# Corpus Christi LNG Project

Docket No. CP12-507-000  
Docket No. CP12-508-000  
DOE Docket No. FE 12-97-LNG  
FERC/EIS-0252F

Corpus Christi LNG Project  
Final Environmental Impact Statement

Figure 3.1-2 Terminal Site Alternatives

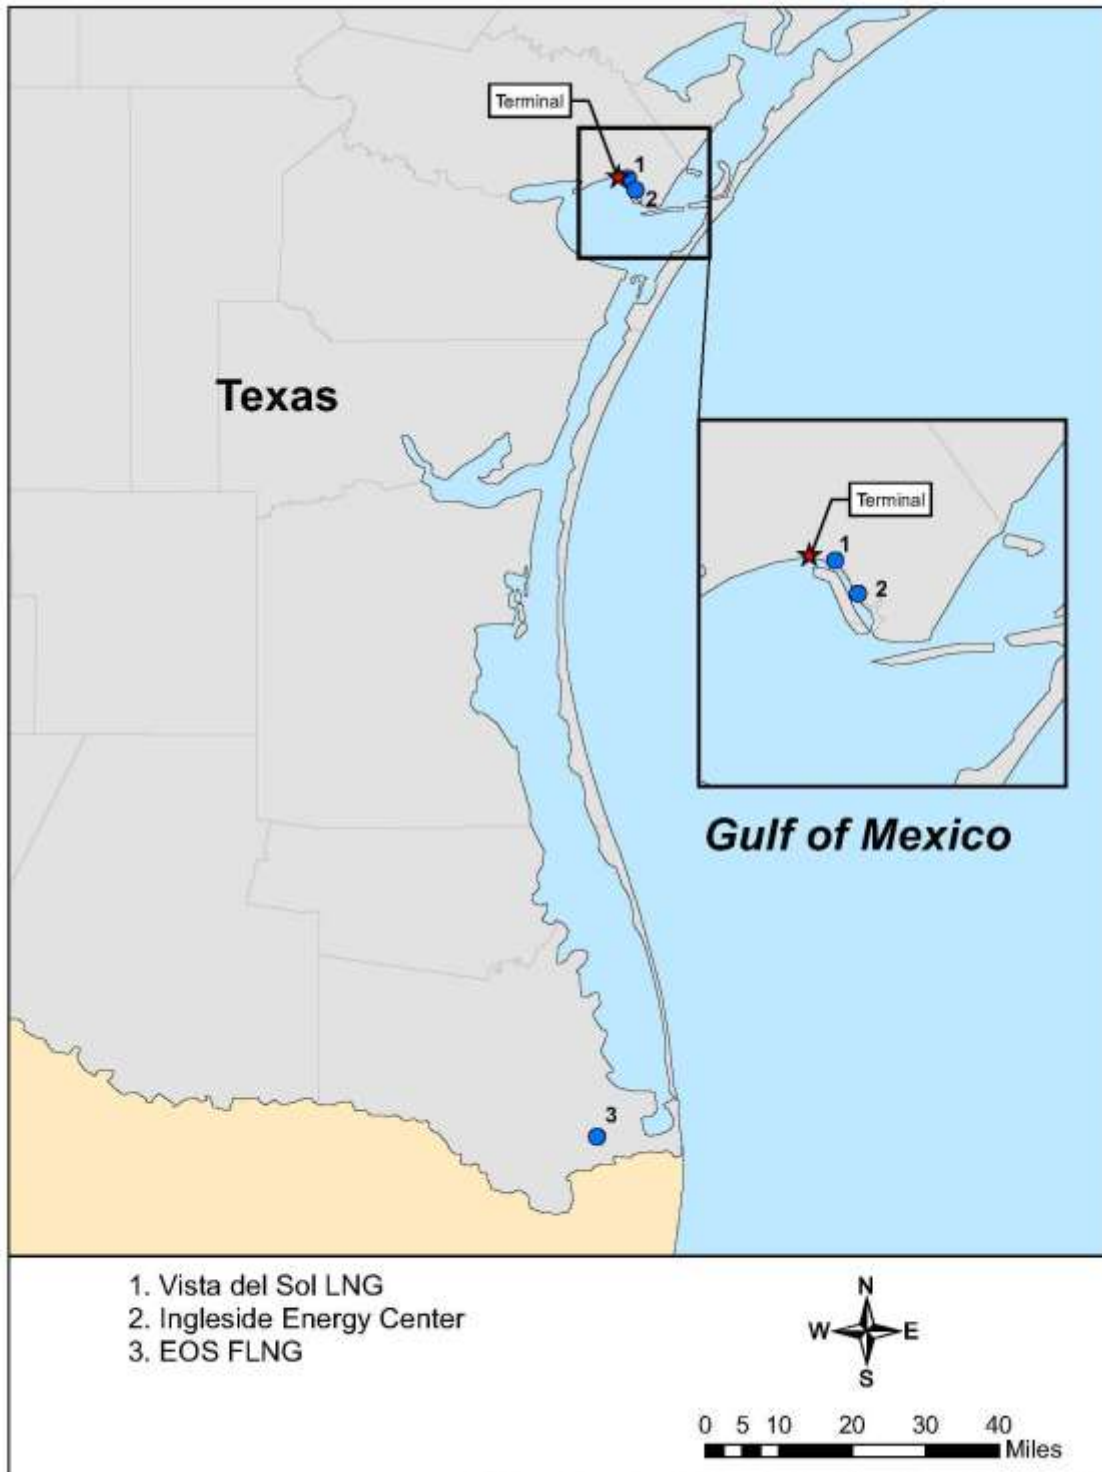
<b>AP1-26</b>	3.0 Alternatives 3.1.4	3-14	Terminal site alternatives Figure 3.1-2	The locations of the Terminal site and the Vista del Sol LNG site appear to be reversed.

##### Earthquake Ground Motion and Faulting

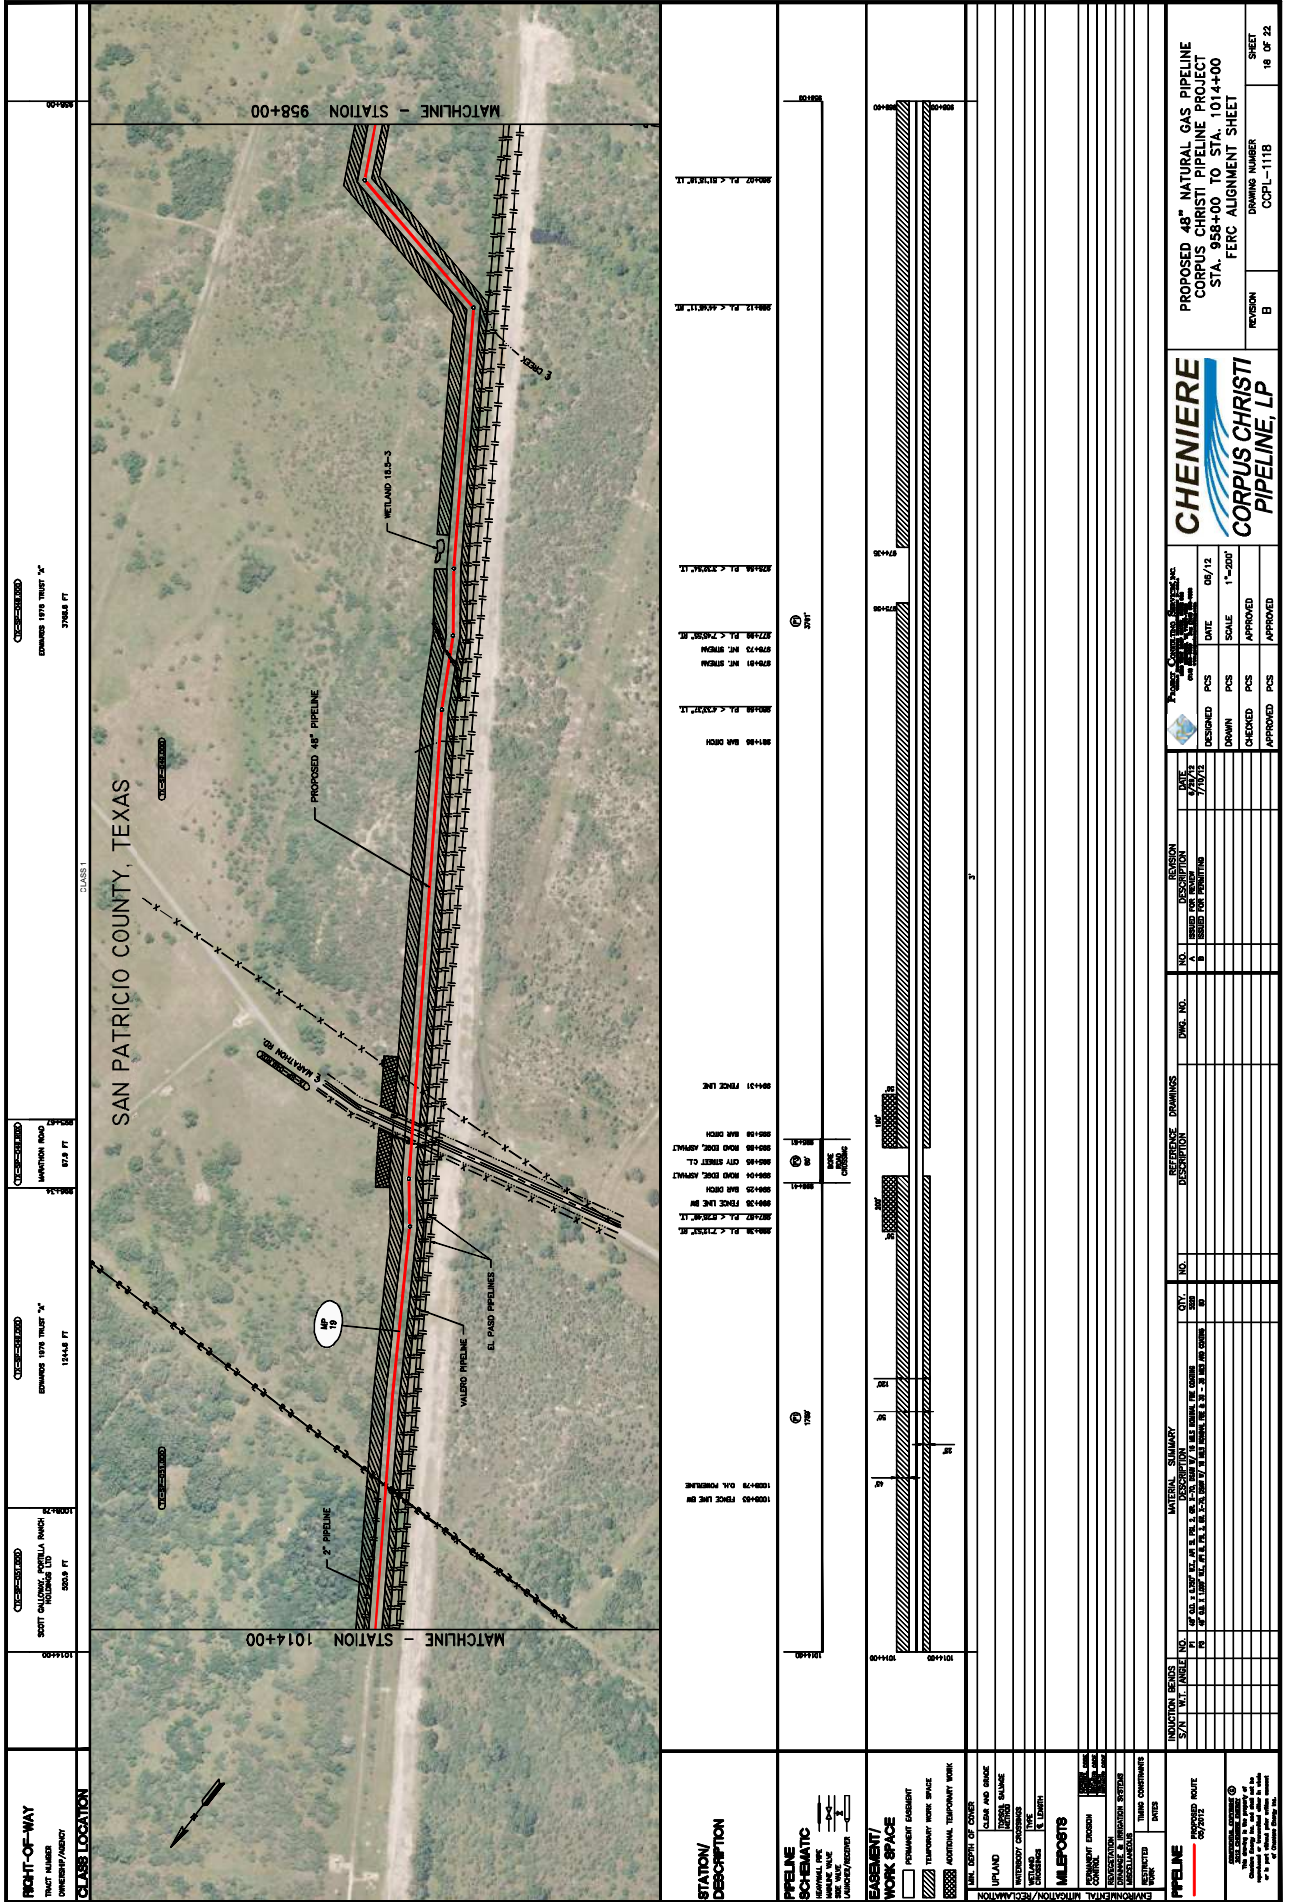
In addition to a drainage ditch, the alignment drawing on Sheet 18 of 22 in Appendix A indicates the presence of an intermittent stream located almost entirely within the construction ROW at MP 18.5. However, neither Table 4.3-3 nor the text acknowledges the presence of this feature. Therefore, it is not clear if impacts have been fully evaluated. Historical aerial imagery of the area indicates that the drainage ditch, intermittent stream, and wetland features illustrated on Sheet 18 were likely part of the Tributary to Chiltipin Creek described at MP 18.0 prior to the construction of other pipelines in the area.
